**SUBDIVISION,
SIDEWALK WAIVER, &
PLANNING APPROVAL STAFF REPORT****Date: September 1, 2022****APPLICANT NAME**

Fulton Tract Subdivision

LOCATION1705 Dauphin Island Parkway
(East side of Dauphin Island Parkway, at the West terminus
of Douglas Lane).**CITY COUNCIL
DISTRICT**

CONTEMPLATED USESubdivision Approval to create one (1) legal lot of record
from one (1) metes-and-bounds parcel, a Sidewalk Waiver
to waive construction of a sidewalk along Dauphin Island
Parkway, and Planning Approval to allow a transit vehicle
storage facility in a B-3, Community Business District.**TIME SCHEDULE
FOR DEVELOPMENT**

SITE PLAN

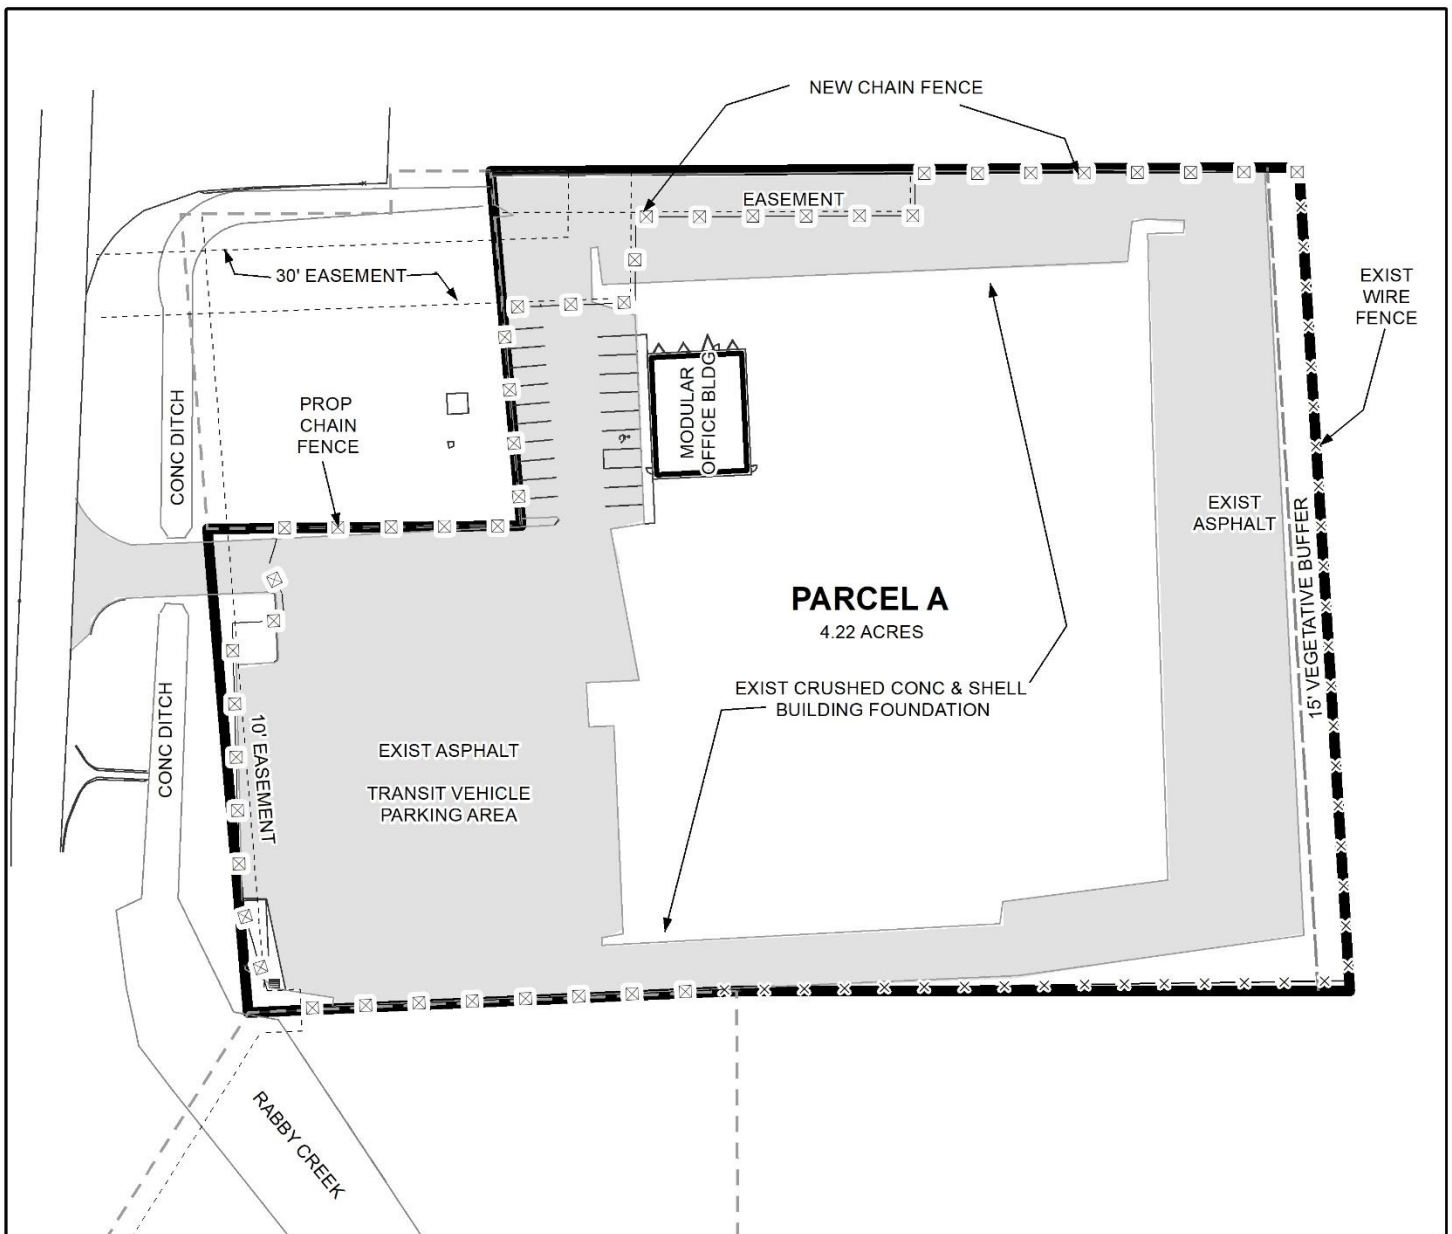
Regarding Planning Approval, the site plan illustrates a 2,800 square foot modular office building on the site, with 19 standard parking spaces depicted and a paved area labeled as "transit vehicle parking area". The site is required to have 10 parking spaces.

The site plan depicts an existing 15-foot vegetative buffer to remain along the Eastern property line, where the property abuts an R-1, Single-Family Residential District, which is developed as a cemetery. If approved, this should be retained on the site plan.

The site plan submitted depicts an existing chain link fence with barbed wire at the East property line, with the fence proposed to be extended so that it encompasses the majority of the subject site. If approved, the site plan should be revised to state the height of the proposed chain link fence shall not exceed 8-feet. It should be noted that there is a gate access to the site, with the gate setback approximately 37.7±-feet from the property line, and not 60-feet as required by the Zoning Ordinance. If approved, either a note should be placed on the site plan stating that the gate will be electrically operated, that the gate will be open during hours of operations, or will need to be relocated to be a minimum of 60-feet from the property line.

No tree planting or landscaping area information is provided on the site plan submitted. The site was previously developed with a hotel, which was demolished in 2006, with permits. As the site is proposed to be re-developed, full compliance with tree planting and landscape area is required. It appears that the site will not have sufficient front landscape area or sufficient landscape area to plant frontage trees, as proposed. If approved, the site plan should be revised to illustrate full compliance with landscaping and tree requirements. Tree plantings should be coordinated with staff to insure the trees have sufficient room to grow and thrive.

The site plan identifies a large area as "existing crushed concrete and shell building foundation". As this is not an allowable surfacing for vehicular parking and maneuvering, the site pan should

be revised to either depict that area as being paved with asphalt or concrete, or curbing or bumper stops should be provided to prevent vehicles on the property from utilizing that portion of the site.

There is no dumpster depicted on the proposed site plan. As such, the site plan should be revised to either depict a dumpster with compliant sanitary sewer connection and enclosure, or provide a note stating that curbside pickup will be utilized.

- 1) Revision of the site plan to illustrate the existing right-of-way along Dauphin Island Parkway;
- 2) Revision of the site plan to provide the lot size in square feet and acres, or provision of a table on the site plan with the same information;

- 3) Revision of the site plan to illustrate the 25-foot minimum building setback line along Dauphin Island Parkway;
- 4) Placement of a note on the site plan to state that no structures are allowed in any easement without the approval of the easement holder;

- 5) Revision of the site plan to include the height of the proposed chain link fence (not to exceed 8-feet high);
- 6) Revision of the site plan to either place a note stating that the gate will be electrically operated, that the gate will be open during hours of operations, or will need to be relocated to be a minimum of 60-feet from the property line;

- 7) Revision of the site plan to depict full compliance with tree planting and landscape area requirements;
- 8) Revision of the site plan to depict either bumper stops or curbing to prevent vehicles from utilizing the “existing crushed concrete and shell building foundation” as parking or maneuvering space or paving said area with compliant materials;

- 9) Revision of the site plan to depict a sidewalk along Dauphin Island Parkway;
- 10) Revision of the site plan to either depict a dumpster with compliant sanitary sewer connection and enclosure, or provide a note stating that curbside pickup will be utilized;
